SERVICE BULLETIN

N° **189-381**

ATA 11 – ADDITIONAL MARKINGS FOR CS26 AMDT 4 KIT INSTALLATION

This SB is applicable to all AW189 helicopters operating under EASA authority that make over water operations in accordance with point CAT.IDE.H.320(a) of Annex IV to Regulation (EU) No 965/2012.

Figure 8

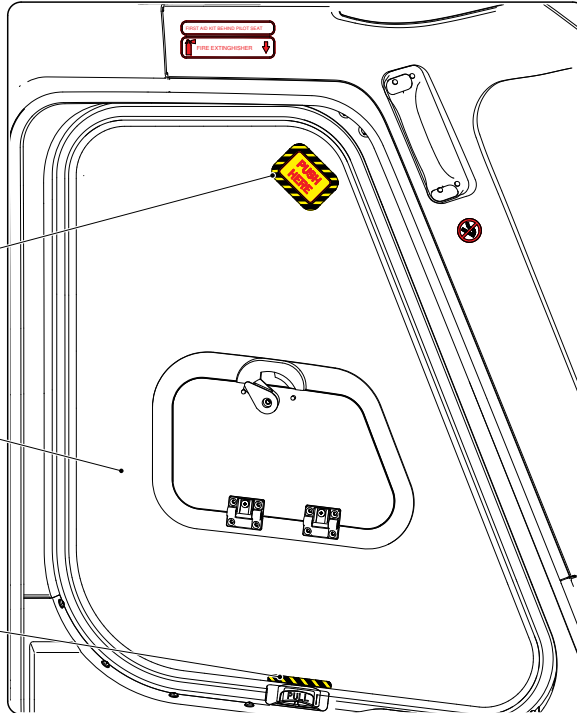
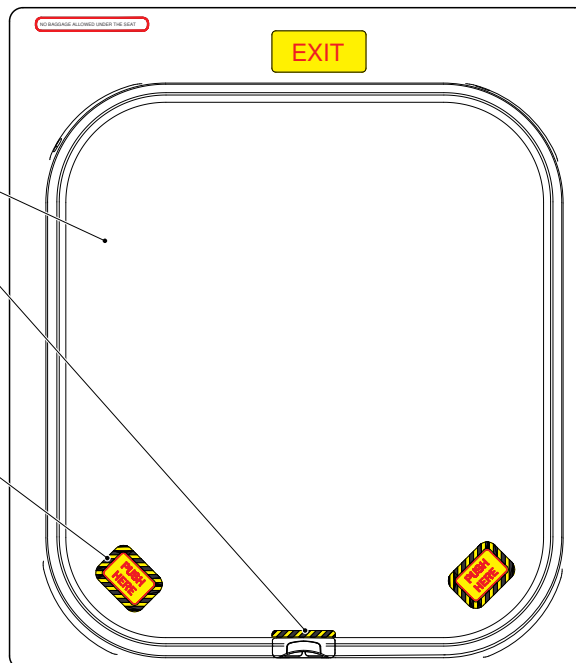
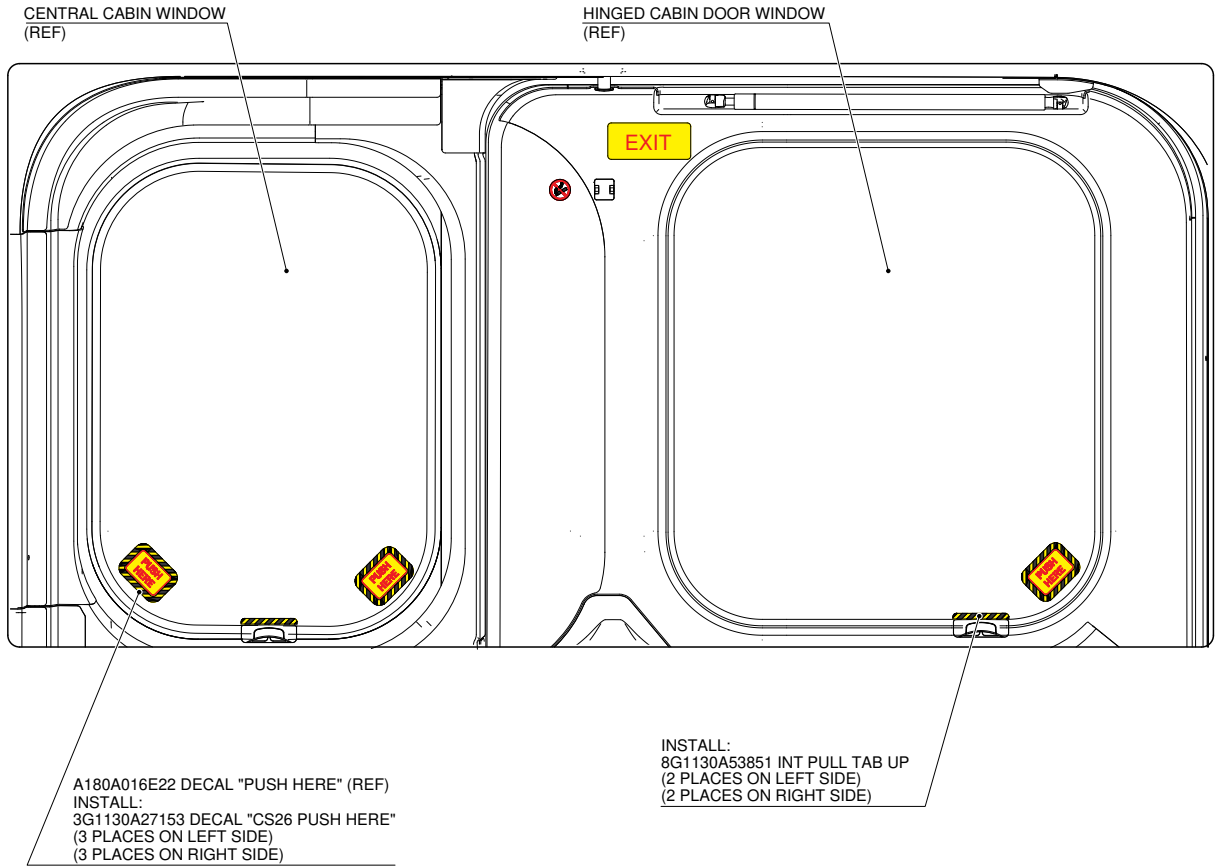
18. In accordance with AMP DM 89-A-11-00-01-00A-720A-A and with reference to Figure 8 Detail P, install the decal P/N 8G1130A53851 and the decal P/N 3G1130A27153 on the LH or RH cockpit door window.

19. In accordance with AMP DM 89-A-11-00-01-00A-720A-A and with reference to Figure 8 Detail Q, install the decal P/N 8G1130A53851 and n°2 decals P/N 3G1130A27153 on the LH or RH forward cabin window.

Figure 9

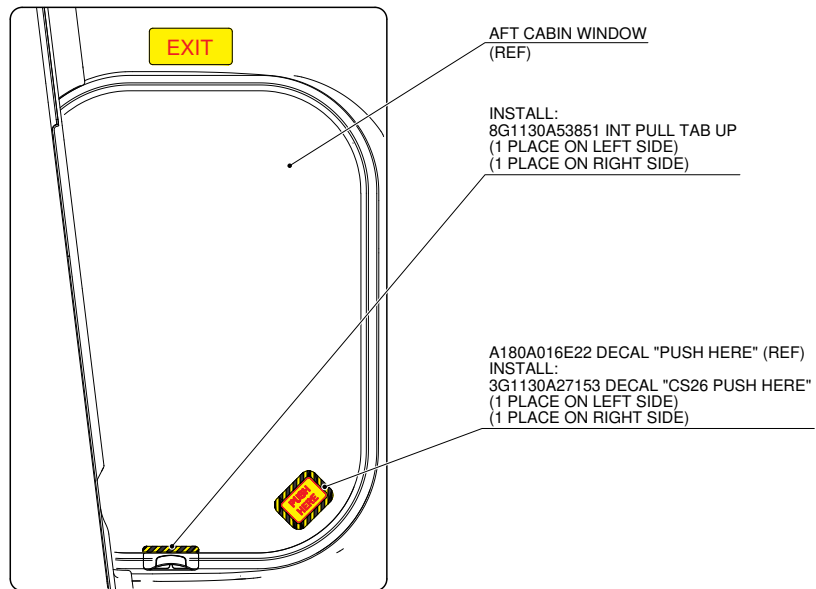
22. In accordance with AMP DM 89-A-11-00-01-00A-720A-A and with reference to Figure 9 Detail R, install the decal P/N 8G1130A53851 and the decal P/N 3G1130A27153 on the LH or RH hinged cabin door window.

23. In accordance with AMP DM 89-A-11-00-01-00A-720A-A and with reference to Figure 9 Detail R, install the decal P/N 8G1130A53851 and n°2 decals P/N 3G1130A27153 on the LH or RH central cabin window.

24. In accordance with AMP DM 89-A-11-00-01-00A-720A-A and with reference to Figure 9 Detail S, install the decal P/N 8G1130A53851 and the decal P/N 3G1130A27153 on the LH or RH aft cabin window.
25. Repeat steps 2 thru 24 for the other side of the helicopter.
26. Return the helicopter to flight configuration and record for compliance with Part II of this Service Bulletin on the helicopter logbook.
27. Gain access to My Communications section on Leonardo WebPortal and compile the “Service Bulletin Application Communication”.

Figure 10

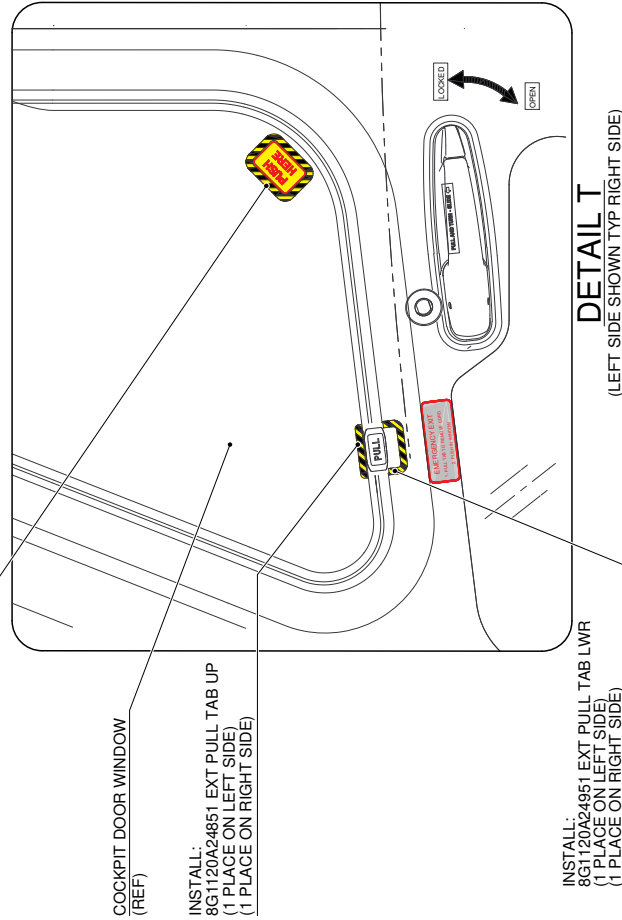
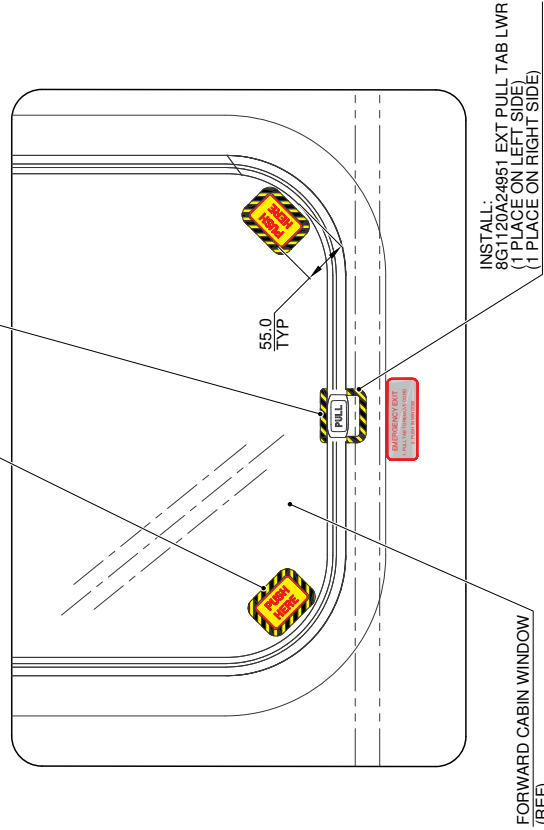
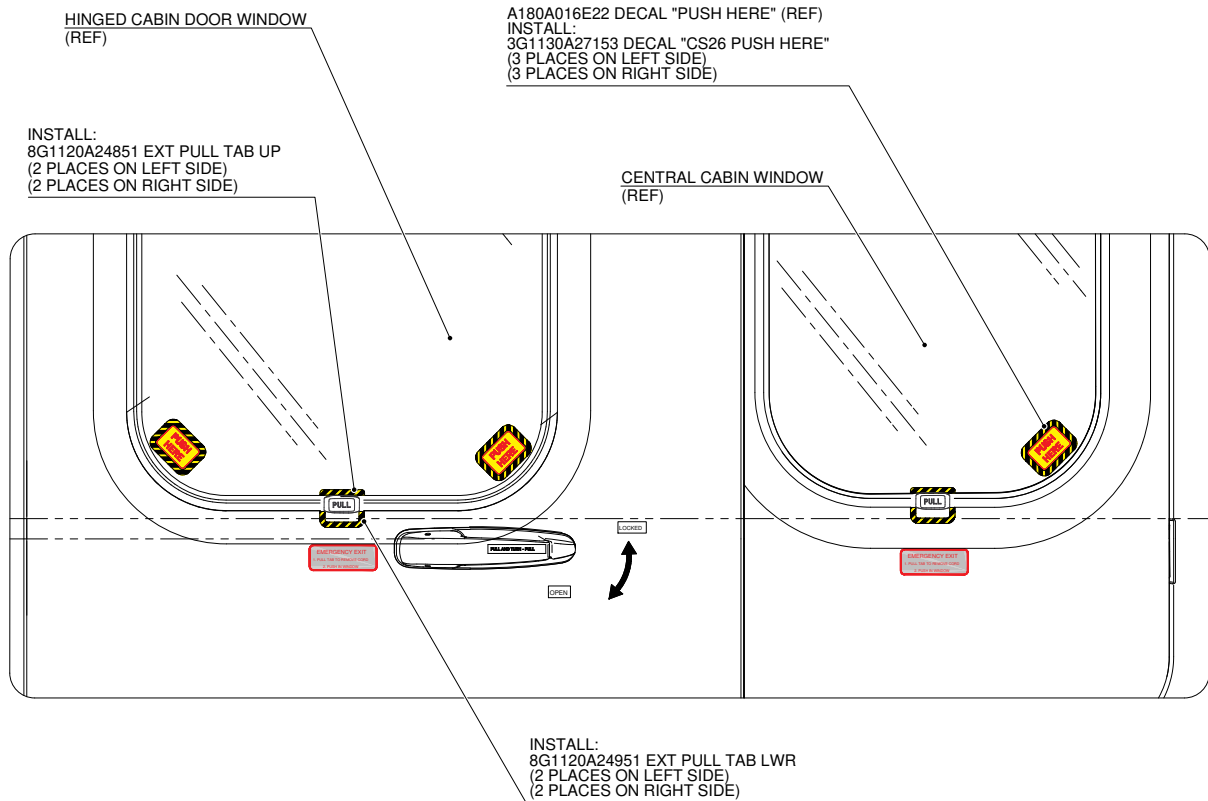
3. In accordance with AMP DM 89-A-11-00-01-00A-720A-A and with reference to Figure 10 Detail T, install the decal P/N 8G1120A24851 and the decal P/N 3G1130A27153 on the LH or RH cockpit door window.

4. In accordance with AMP DM 89-A-11-00-01-00A-720A-A and with reference to Figure 10 Detail U, install the decal P/N 8G1120A24951 on the LH or RH forward cabin window frame.

5. In accordance with AMP DM 89-A-11-00-01-00A-720A-A and with reference to Figure 10 Detail U, install the decal P/N 8G1120A24851 and n°2 decals P/N 3G1130A27153 on the LH or RH forward cabin window.

Figure 11

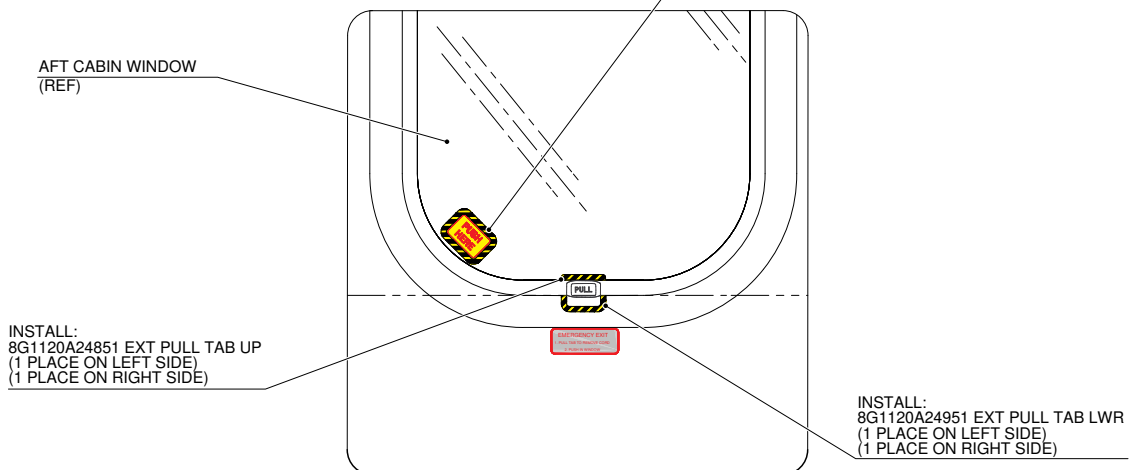
9. In accordance with AMP DM 89-A-11-00-01-00A-720A-A and with reference to Figure 11 Detail V, install the decal P/N 8G1120A24851 and n°2 decals P/N 3G1130A27153 on the LH or RH hinged cabin door window.
10. In accordance with AMP DM 89-A-11-00-01-00A-720A-A and with reference to Figure 11 Detail V, install the decal P/N 8G1120A24951 on the LH or RH central cabin window frame.

11. In accordance with AMP DM 89-A-11-00-01-00A-720A-A and with reference to Figure 11 Detail V, install the decal P/N 8G1120A24851 and the decal P/N 3G1130A27153 on the LH or RH central cabin window.

12. In accordance with AMP DM 89-A-11-00-01-00A-720A-A and with reference to Figure 11 Detail W, install the decal P/N 8G1120A24951 on the LH or RH aft cabin window frame.

13. In accordance with AMP DM 89-A-11-00-01-00A-720A-A and with reference to Figure 11 Detail W, install the decal P/N 8G1120A24851 and the decal P/N 3G1130A27153 on the LH or RH aft cabin window.

Figure 13

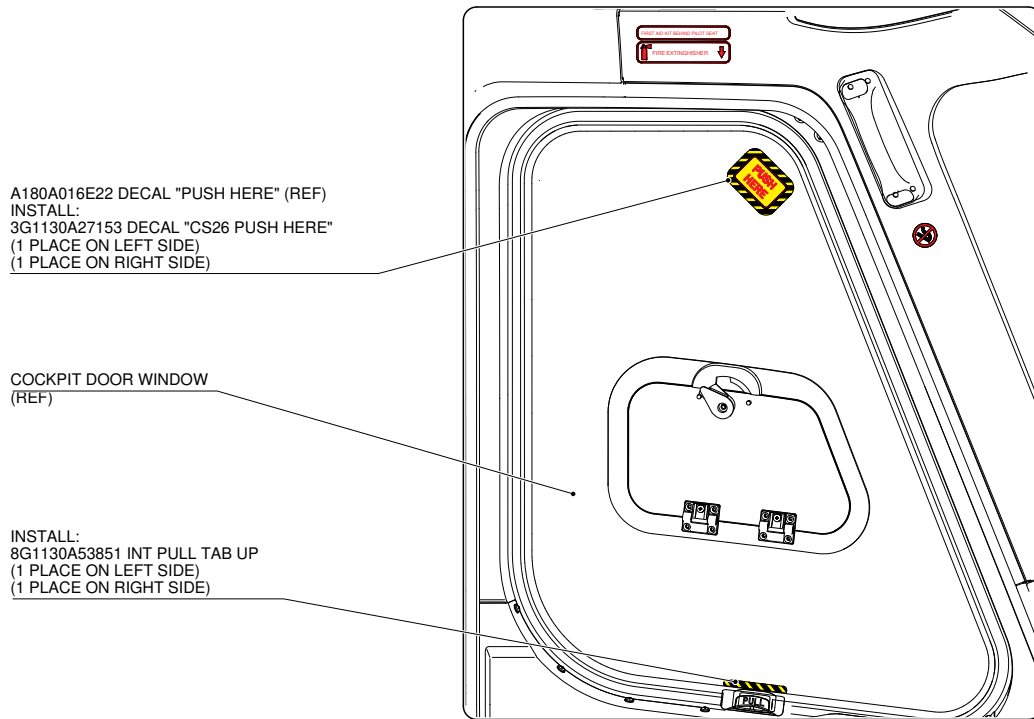
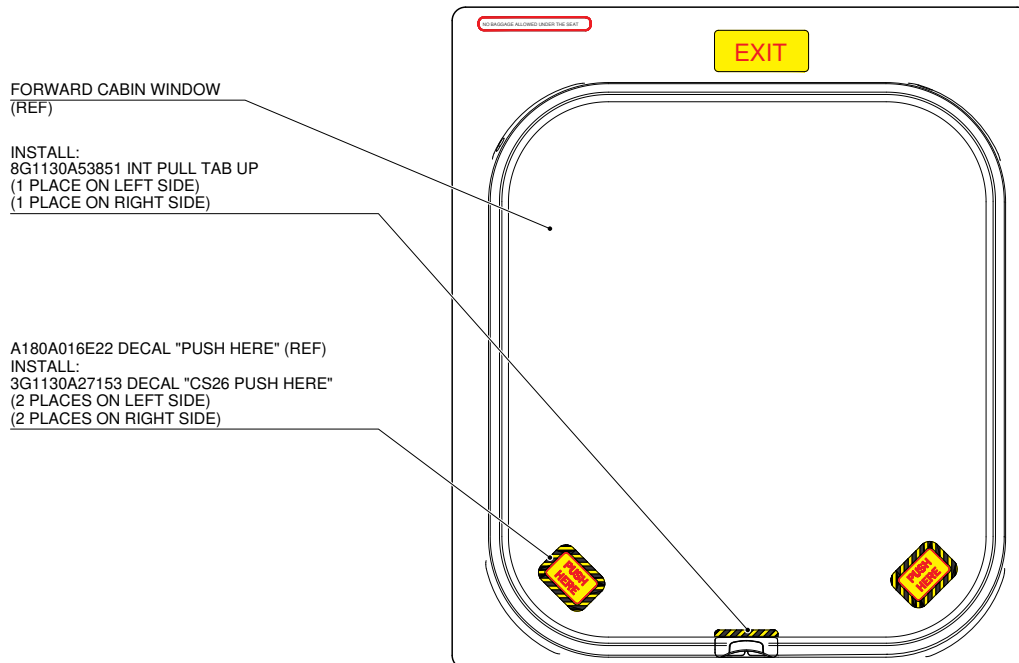
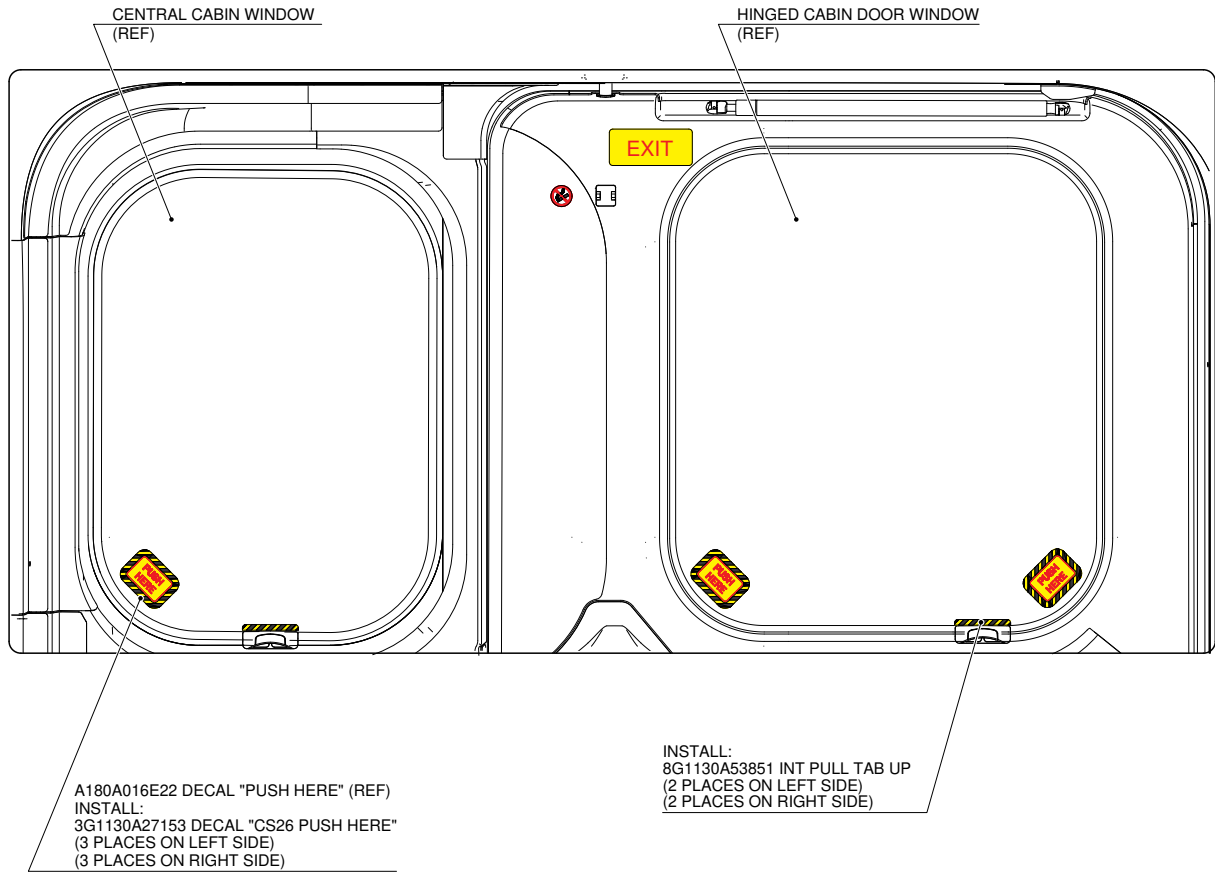
18. In accordance with AMP DM 89-A-11-00-01-00A-720A-A and with reference to Figure 13 Detail Y, install the decal P/N 8G1130A53851 and the decal P/N 3G1130A27153 on the LH or RH cockpit door window.

19. In accordance with AMP DM 89-A-11-00-01-00A-720A-A and with reference to Figure 13 Detail Z, install the decal P/N 8G1130A53851 and n°2 decals P/N 3G1130A27153 on the LH or RH forward cabin window.

Figure 19

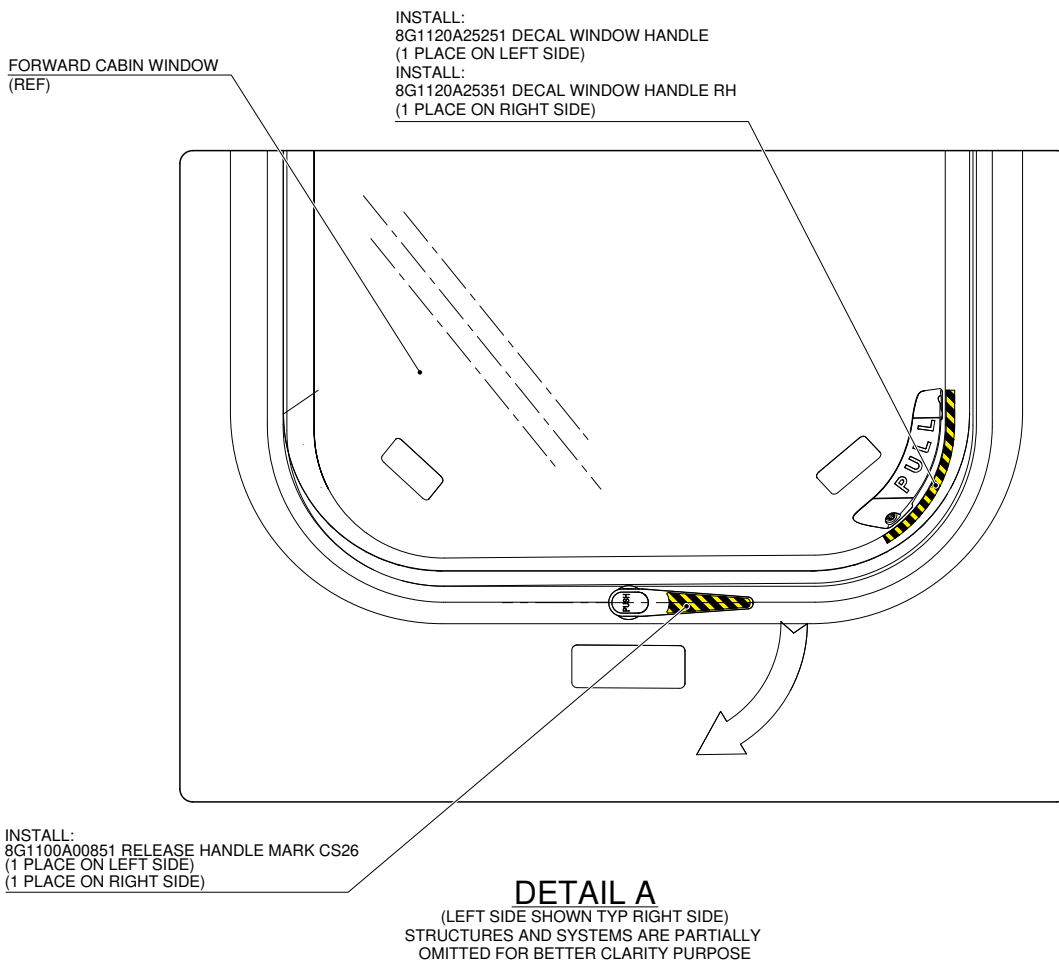
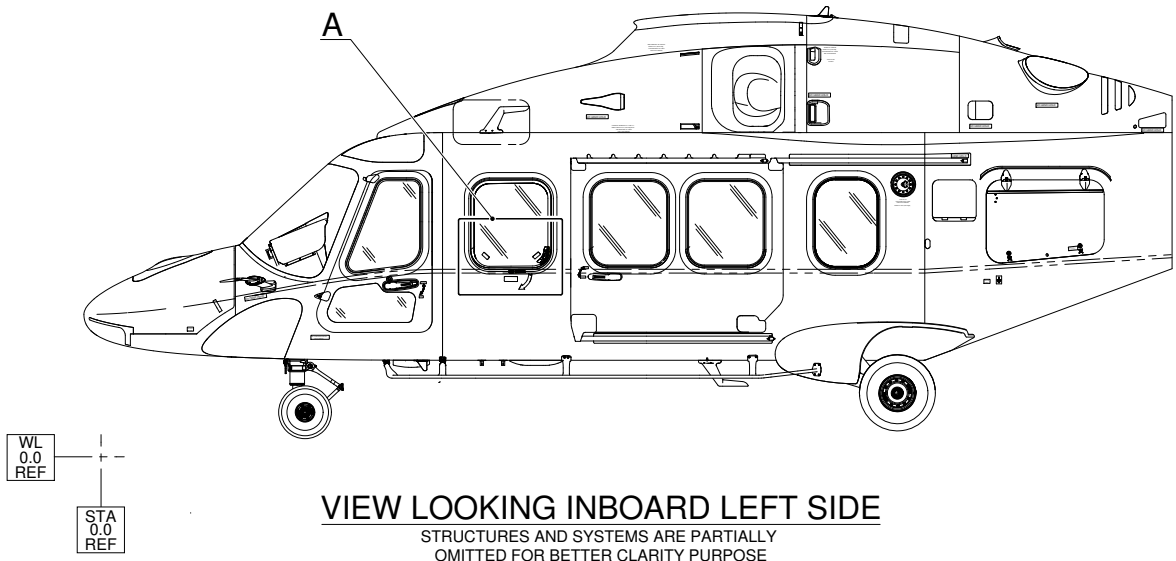
6. In accordance with AMP DM 89-A-11-00-01-00A-720A-A and with reference to Figure 19 Detail A, install the decal P/N 8G1120A25251 or the decal P/N 8G1120A25351 on the LH or RH forward cabin window.
7. In accordance with AMP DM 89-A-11-00-01-00A-720A-A and with reference to Figure 19 Detail A, install the decal P/N 8G1100A00851 on the release handle of the LH or RH forward cabin window.
8. In accordance with AMP DM 89-A-11-00-01-00A-720A-A and with reference to Figure 2 Detail C, install n°2 decals P/N 8G1120A24951 on the LH or RH cabin sliding door window frame.

6. In accordance with AMP DM 89-A-11-00-01-00A-720A-A and with reference to Figure 19 Detail A, install the decal P/N 8G1120A25251 or the decal P/N 8G1120A25351 on the LH or RH forward cabin window.
7. In accordance with AMP DM 89-A-11-00-01-00A-720A-A and with reference to Figure 19 Detail A, install the decal P/N 8G1100A00851 on the release handle of the LH or RH forward cabin window.
8. In accordance with AMP DM 89-A-11-00-01-00A-720A-A and with reference to Figure 6 Detail L, install the decal P/N 8G1120A24951 on the LH or RH hinged cabin door window frame.

6. In accordance with AMP DM 89-A-11-00-01-00A-720A-A and with reference to Figure 19 Detail A, install the decal P/N 8G1120A25251 or the decal P/N 8G1120A25351 on the LH or RH forward cabin window.
7. In accordance with AMP DM 89-A-11-00-01-00A-720A-A and with reference to Figure 19 Detail A, install the decal P/N 8G1100A00851 on the release handle of the LH or RH forward cabin window.
8. In accordance with AMP DM 89-A-11-00-01-00A-720A-A and with reference to Figure 11 Detail V, install the decal P/N 8G1120A24951 on the LH or RH hinged cabin door window frame.
